Access Compliance Report Public Rights-of-Way (Curb Ramps)

Main Street: NEWPORT_BLVD		Cross Street: CRAWFORD_CANYON_RD		Location:	NW
ADA ID: RPRK211012172418	Ramp Type:Type 1 - Perpendicular Diagonal Initial Pass/Fail: Fail		Overall Compliance: No	Severity Score:	45
Codes/Mitigation Info/Possible Solution			Field Measurements/Component Compliance

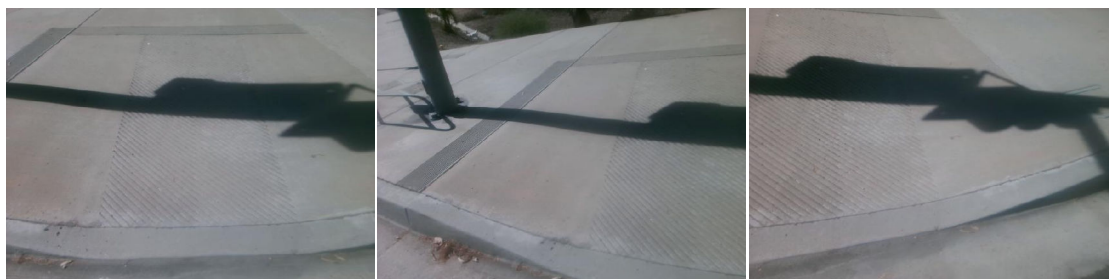
Compliance	Description	Data	Compliance	Description	Data
N/A	Ramp Length (in)	108	N/A	Flare Type LT	
Yes	Ramp Width (in)	48			N/A
No	Ramp Run Slope (%)	8.5	N/A	Flare Slope LT (%)	N/A
No	Ramp Cross Slope (%)	7.1	N/A	Flare Traversable LT	N/A
N/A	Landing Present	N/A	N/A	Flare Type RT	
N/A	Landing Length (in)	N/A			N/A
N/A	Landing Width (in)	N/A	N/A	Flare Slope RT (%)	N/A
N/A	Landing Run Slope (%)	N/A	N/A	Flare Traversable RT	N/A
N/A	Landing Cross Slope (%)	N/A	N/A	DWS Provided	N/A
N/A	Landing Movement Obstructed?	N/A	N/A	DWS Contrast	N/A
	Landing Movement Type	N/A	N/A	DWS Length (in)	N/A
N/A	Landing Shared	N/A	N/A	DWS Full Width	N/A
N/A	Clear Space	Yes	N/A	DWS Offset Left (in)	N/A
N/A	Clear Space To Crosswalk (in)	N/A	N/A	DWS Offset Right (in)	N/A
N/A	Marked Crosswalk 1	No	N/A	Marked Crosswalk 2	Yes
	Crossing 1 Direction	S		Crossing 2 Direction	E
	Marked Crosswalk 1 Width (in)	N/A		Marked Crosswalk 2 Width (in)	144

N/A	Ramp Inside Crosswalk 1	N/A	Yes	Ramp Inside Crosswalk 2	No
	Crossing 1 Slope (%)	2.9		Crossing 2 Slope (%)	4.6
	Crossing 1 Cross Slope (%)	6.6		Crossing 2 Cross Slope (%)	5.1
N/A	Gutter Ponding	N/A	No	Curb Slope	10.8
No	Gutter Lip Height (in)	0.25		Road Run Slope (%)	7.4
N/A	Gutter Run Slope (%)	N/A		Road Cross Slope (%)	3.7
N/A	Gutter Cross Slope (%)	N/A			
Yes	Overall Surface Condition: Acceptable		No	Perp Joint Present	No
	Cross Gutter Present?	No		Spandrel Present?	No
	Replace Cross Gutter?	N/A		Replace Spandrel?	N/A

Remove & Replace Curb Ramp With Two New Directional Ramps or Equivalent. Restripe Crosswalk.
